# Service Bulletin

**Bulletin No:** 2009-1-01

**Subject:** Protective Foil

**Affected Models:** 2009 Bearcat Z1 XT, F5, F6, F8, T500, and TZ1 models

Fig. 1

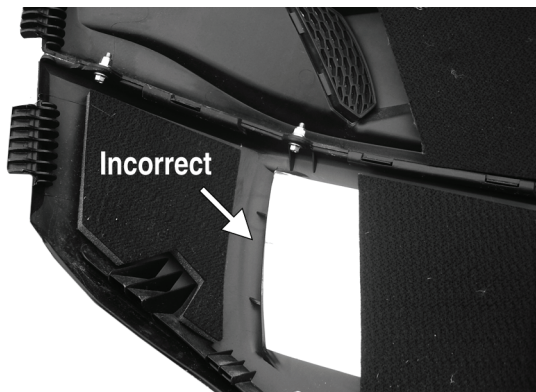
**Condition:** It has come to our attention that the protective foil on the affected models was improperly positioned on the right-side panel. See Fig. 1. Failure to properly position the protective foil may result in damage to the right-side panel.

Fig. 2

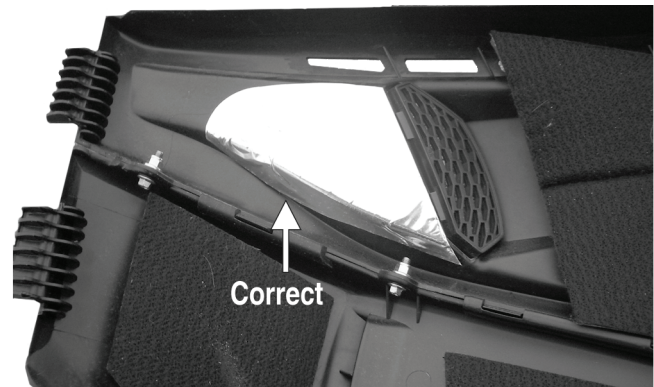
**Solution:** Place Protective Foil (p/n 4606-799) onto the right-side panel according the instructions included in the kit. See Fig. 2.

III. 1

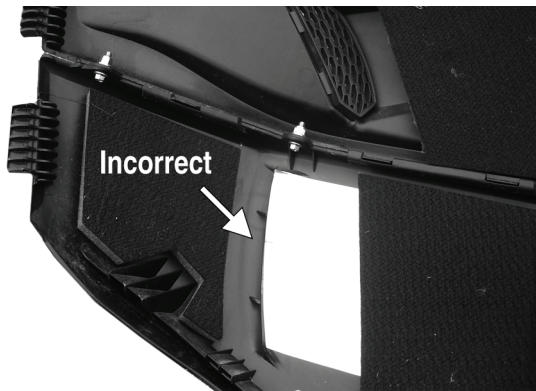
Nous avons remarqué que la feuille métallique protectrice n'a pas été placée correctement sur le panneau latéral droit de certains modèles visés. Consultez l'illustration 1. L'installation incorrecte de la feuille métallique protectrice peut entraîner l'endommagement du panneau latéral droit.

III. 2

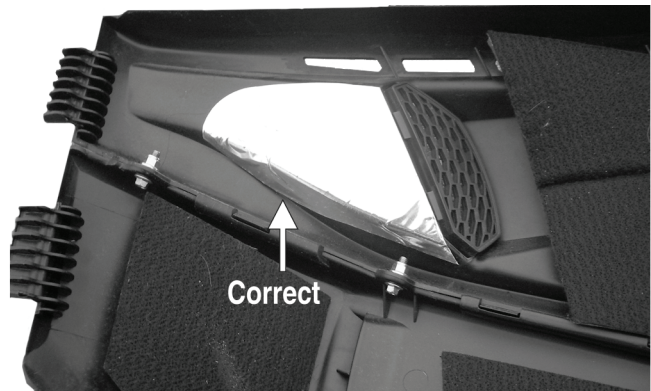
Placez la Feuille métallique protectrice (n/p 4606-799) sur le panneau latéral droit en suivant les instructions comprises dans la trousse. Consultez l'illustration 2.
